PREVOST

WARRANTY BULLETIN

WB16-04

DATE :	FEBRUARY 2016	SECTION :	14 - Steering
EXPIRATION:	FEBRUARY 2018		
SUBJECT :	STEERING DAMPER SECUREMENT

Figure 1

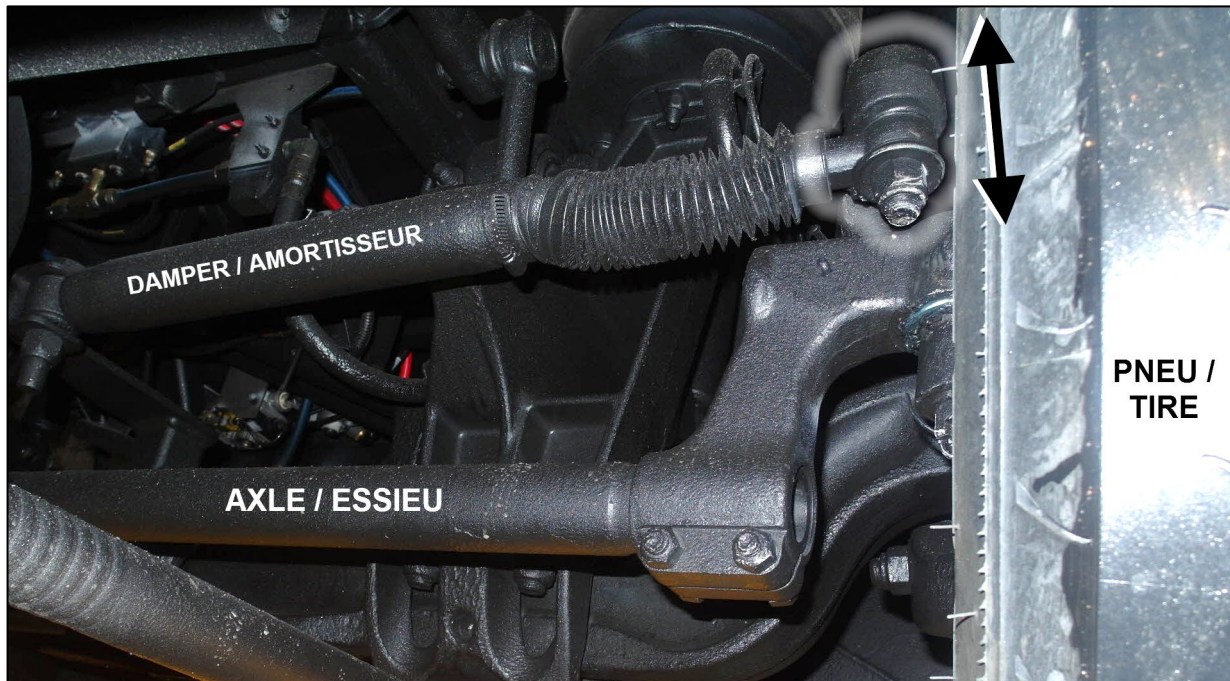
1. Lift vehicle.
2. On front axle the left wheel, locate the steering damper spherical end.(Fig. 1)
3. Make sure there is no vertical play. (Fig. 1)
4. If the spherical bearing moves, replace by a new **660884**.

Figure 2

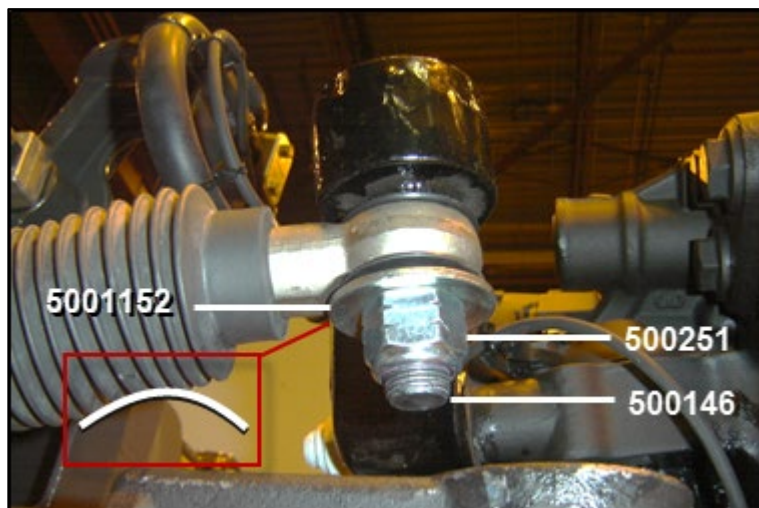
5. Add a washer under the seal é.
Note washer orientation (fig. 2)
5001152 qty 1

Replace le bolt and nut :
500146 qty 1
500251 qty 1

Tighten to **110** lbf-ft.

Apply corrosion inhibitor on the new parts.
